EL PASO COUNTY GRADING AND EROSION CONTROL PLAN CHECKLIST

SPACE VILLAGE FILING NO. 4
A PORTION OF THE NW 1/4 OF SEC. 17, T14S,
R65W, OF THE 6th P.M., EL PASO COUNTY, COLORADO
GRADING & EROSION CONTROL PLAN

SPACE VILLAGE FILING NO. 4
EL PASO COUNTY, CO

DIVERSION SWALE
NOT TO SCALE

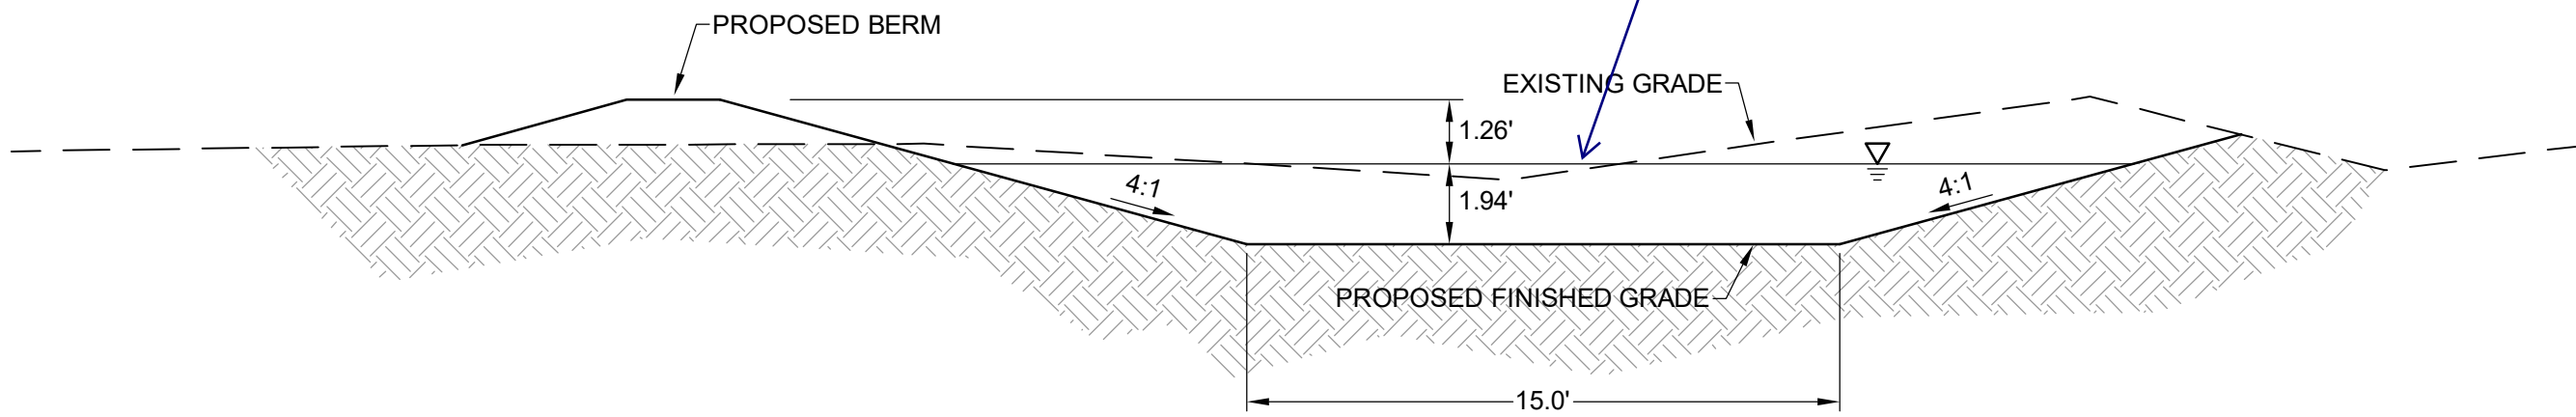
provide top width
distance
